1	2	3	4	5	6
A	Sheet 1 File: Sequencer-Logic-Prod-V2.1-sheet1.kicad_sch					
B	Sheet 2 File: Sequencer-Logic-Prod-V2.1-sheet2.kicad_sch					
C	Sheet 3 File: Sequencer-Logic-Prod-V2.1-sheet3.kicad_sch					
	Sheet 4 File: Sequencer-Logic-Prod-V2.1-sheet4.kicad_sch					
	Sheet 5 File: Sequencer-Logic-Prod-V2.1-sheet5.kicad_sch					
	Sheet 6 File: Sequencer-Logic-Prod-V2.1-sheet6.kicad_sch					
D	Sheet 7 File: Sequencer-Logic-Prod-V2.1-sheet7.kicad_sch				Converted from Eagle schematic; see README.md Sheet: / File: Sequencer-Logic-Prod-V2.1.kicad_sch Title: Sequencer-Logic-Prod-V2.1 Size: A4Date:KiCad E.D.A. 10.0.6 Rev:Id: 1/11	
	1	2	3	4	5	6

Title: Sequencer-Logic-Prod-V2.1 sheet 2

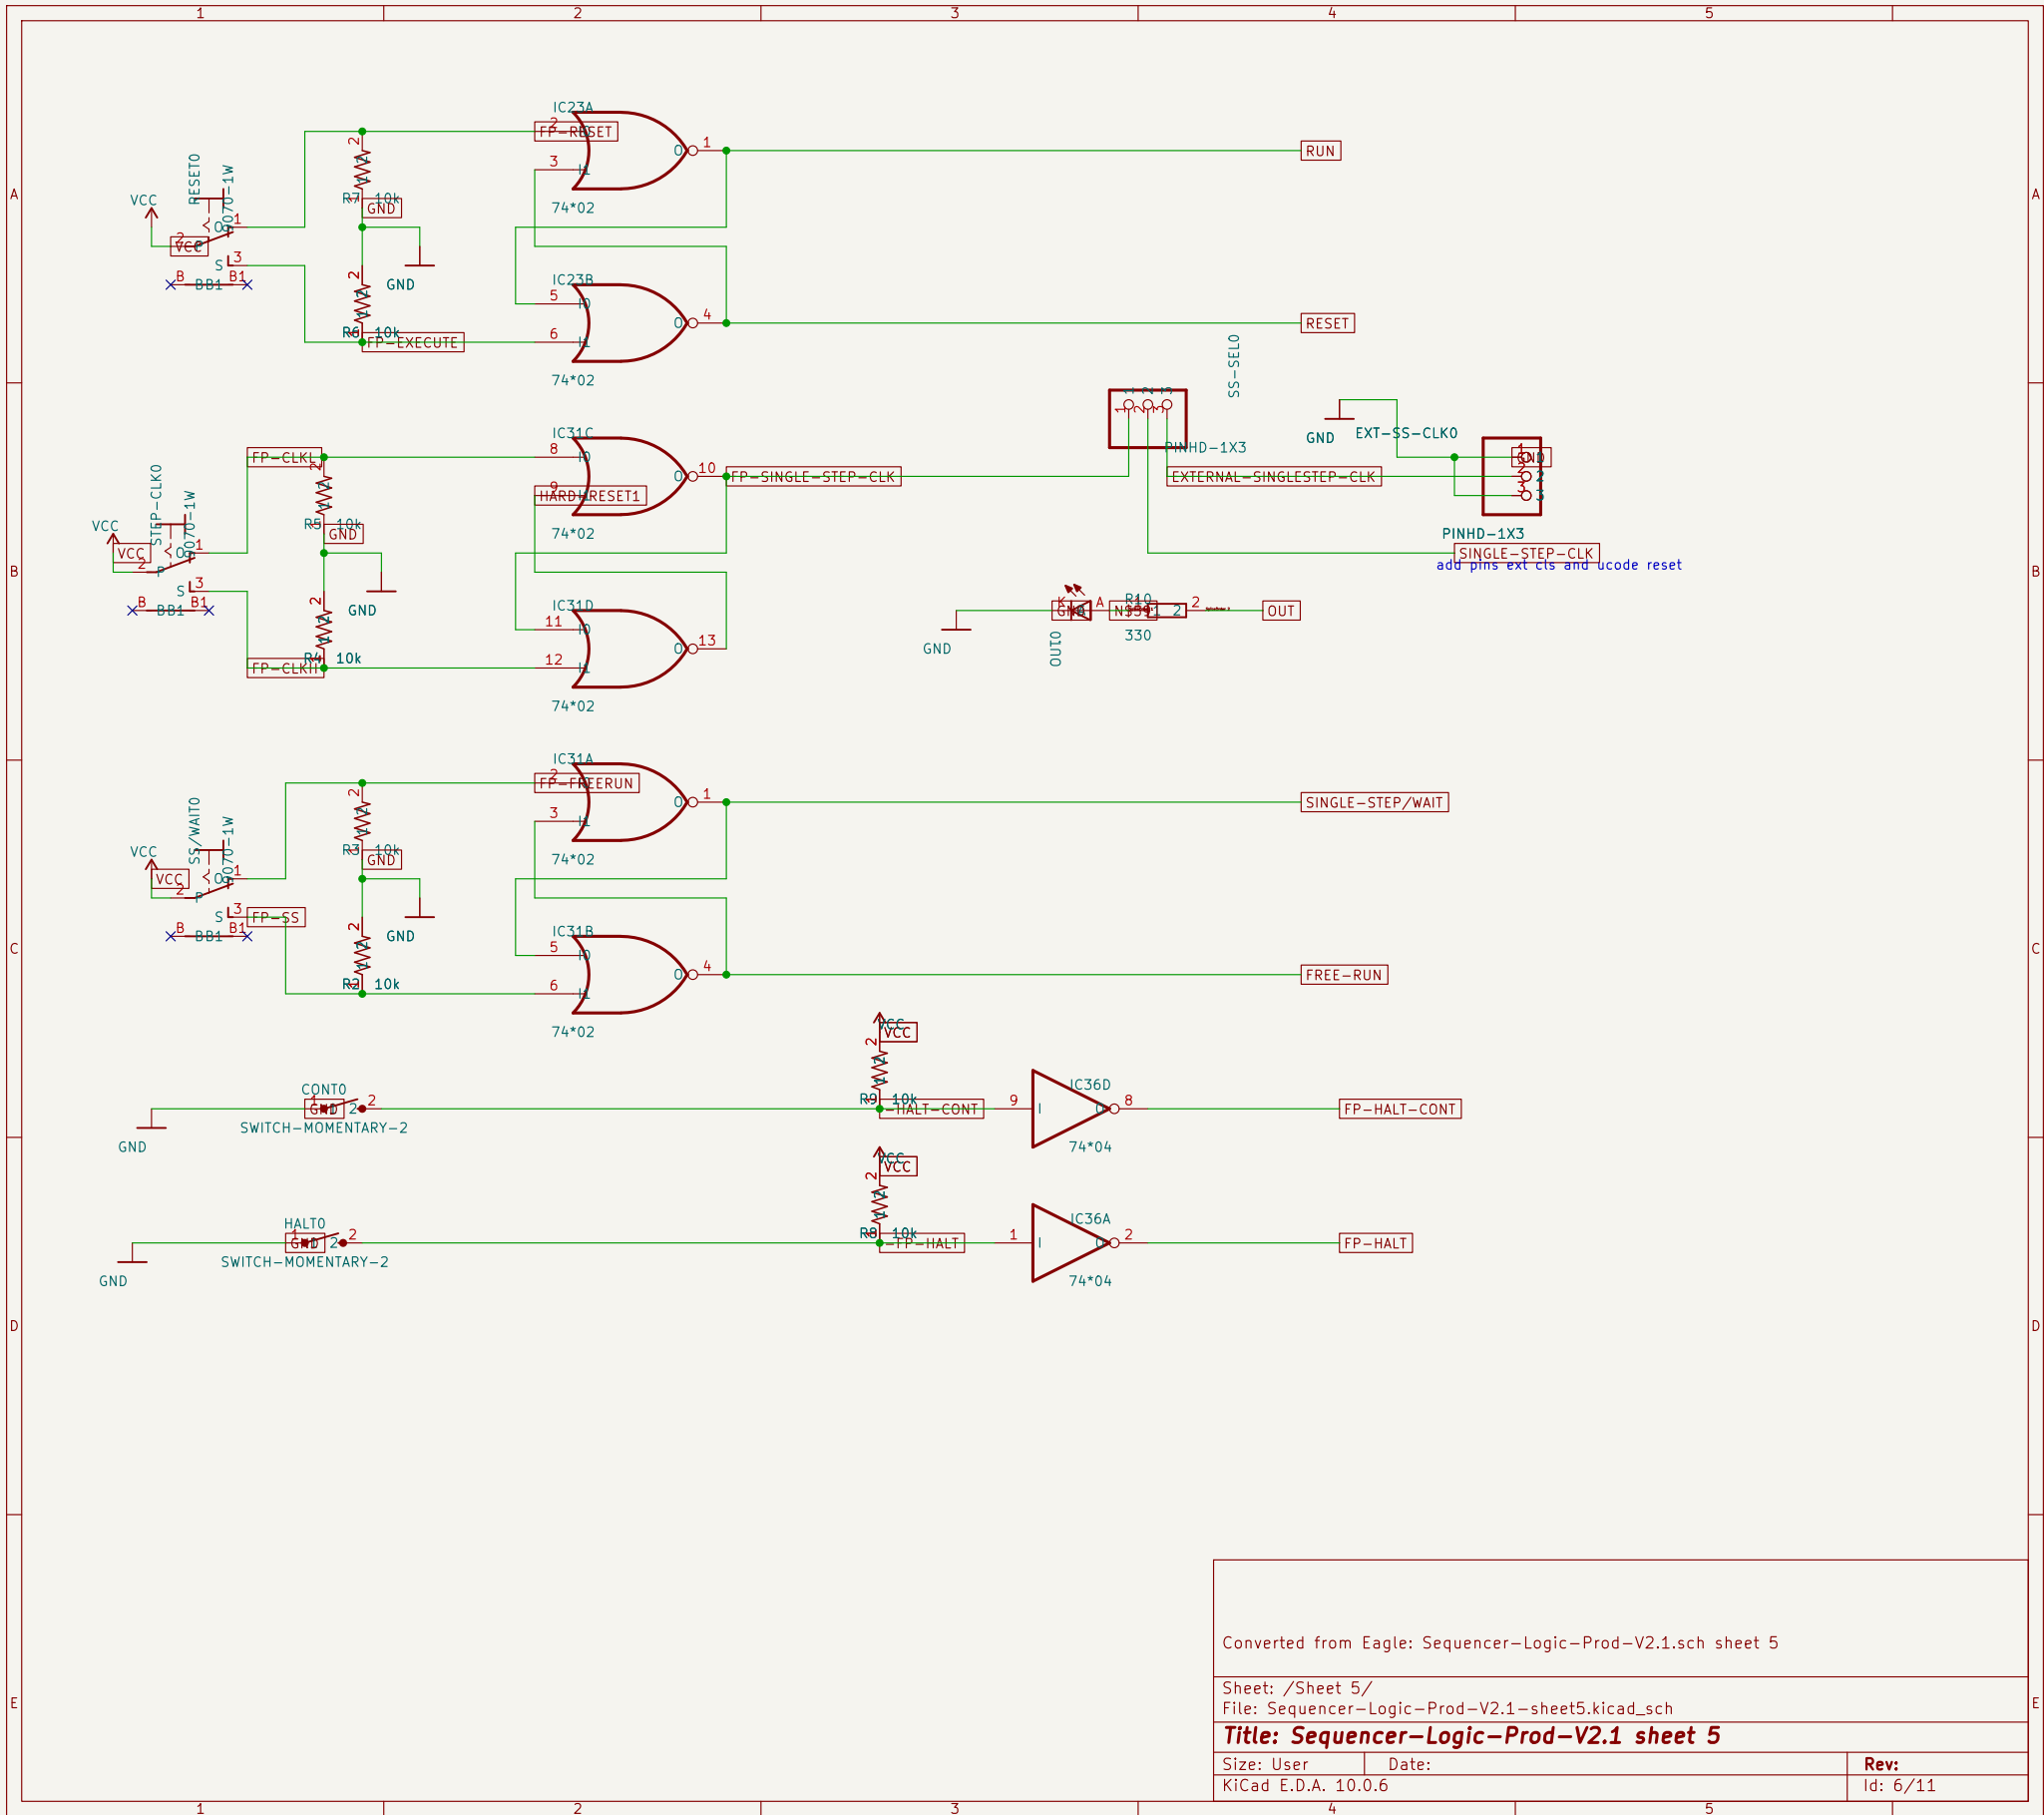
Should operand clk be part of mem-logic or generated signal

Title: Sequencer-Logic-Prod-V2.1 sheet 6

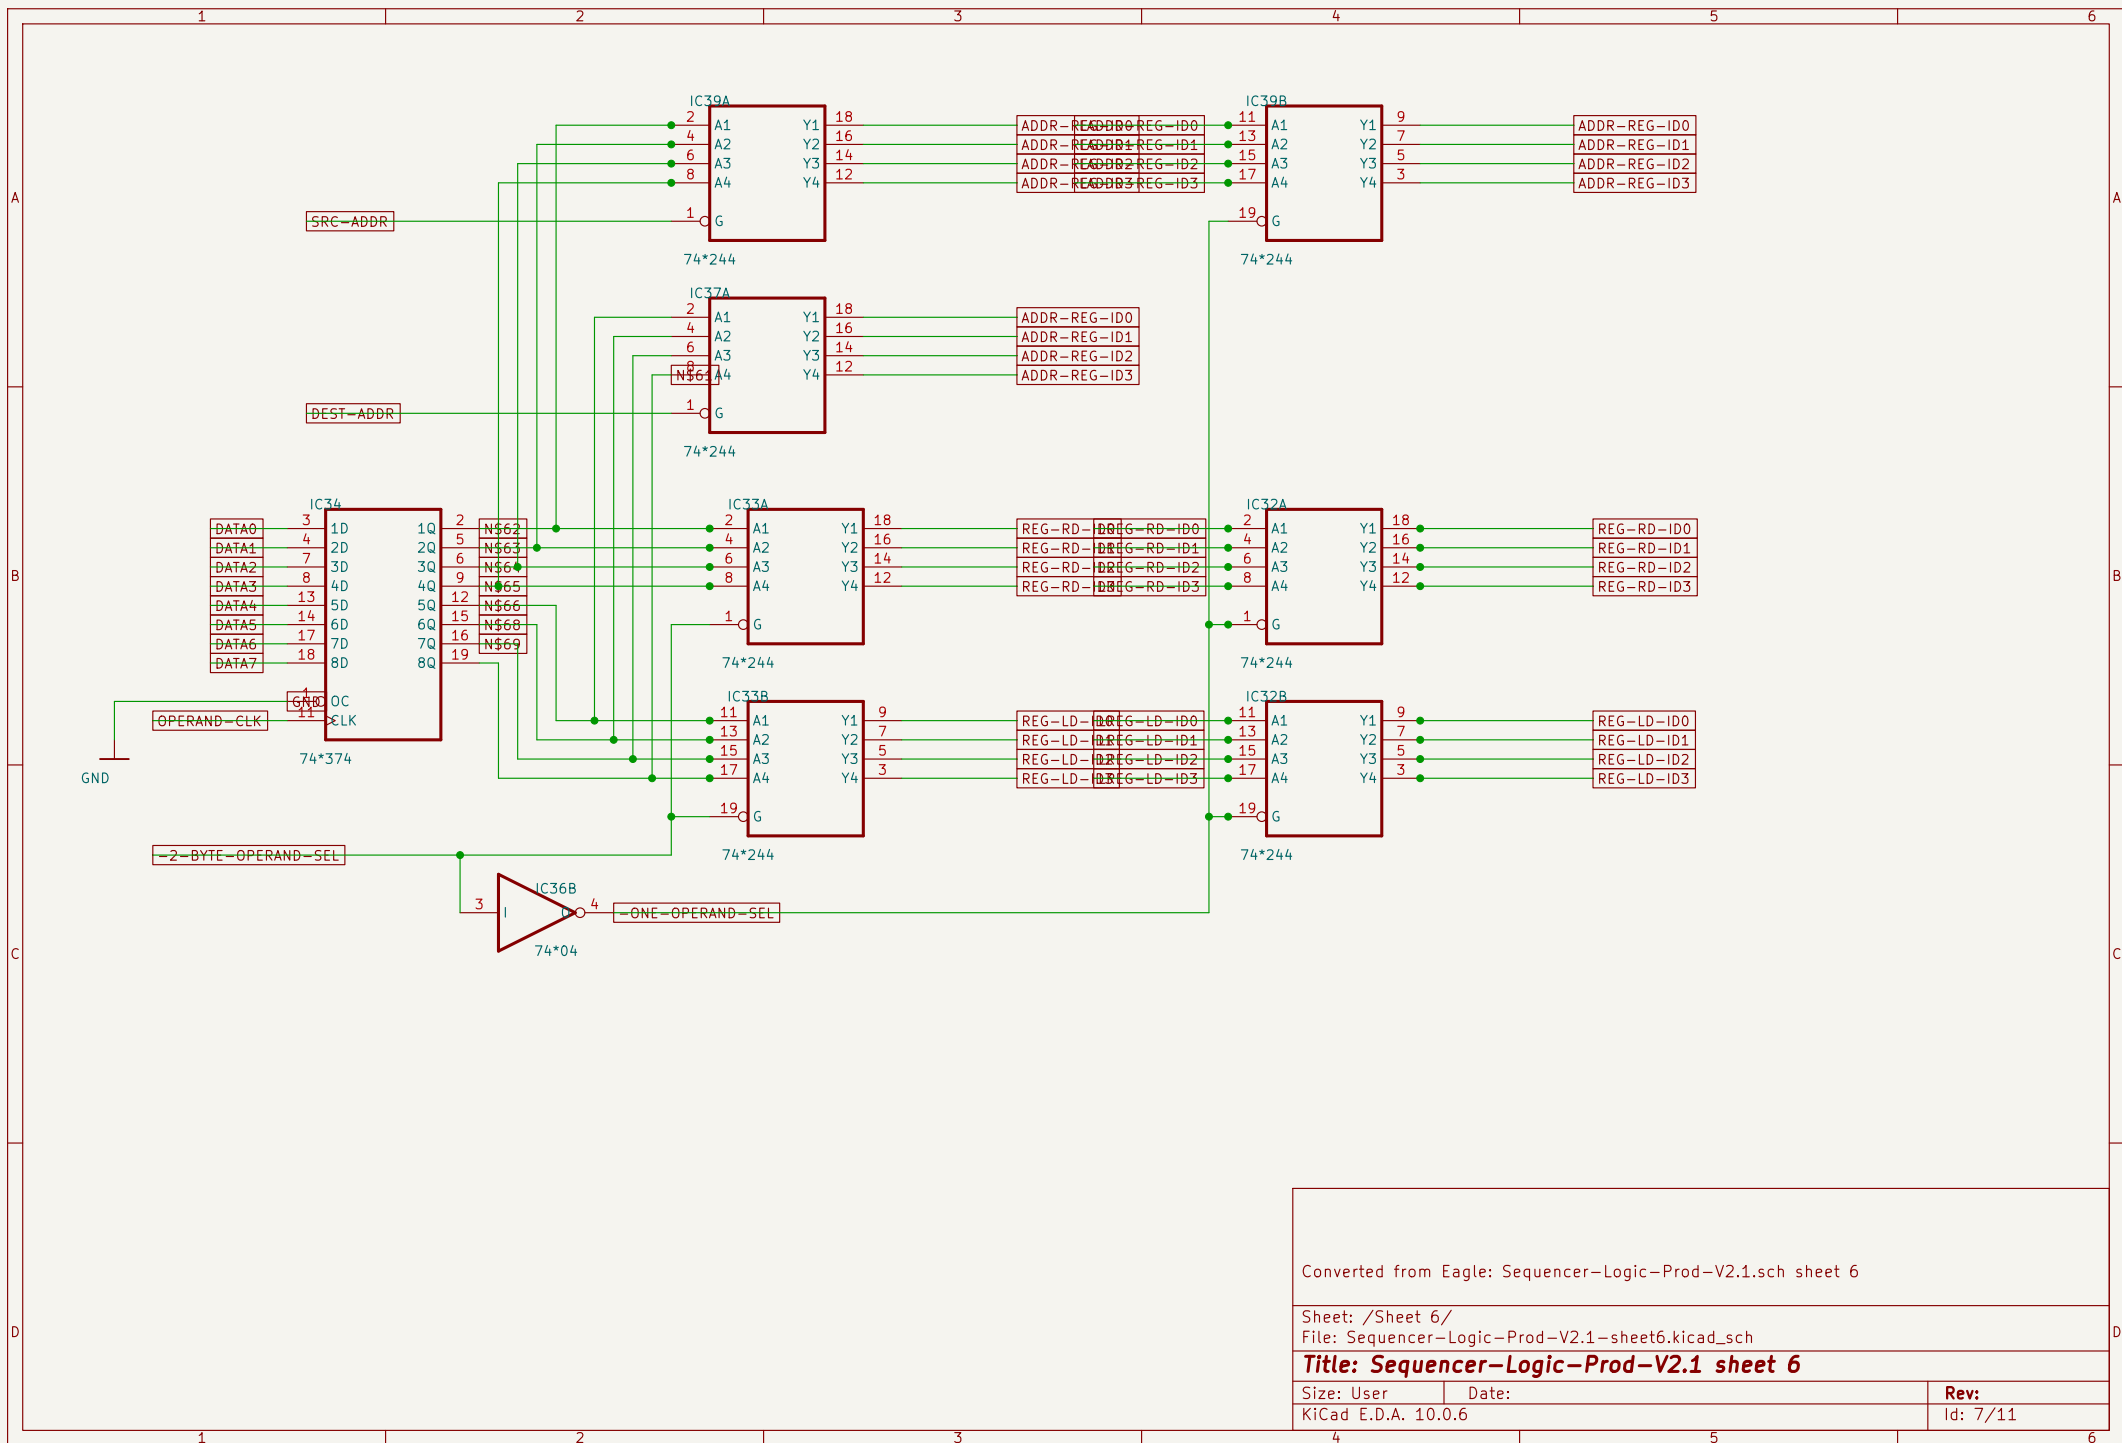
drive reg-rd/ld and ioaddr from separte signals and add to drive addr line driving
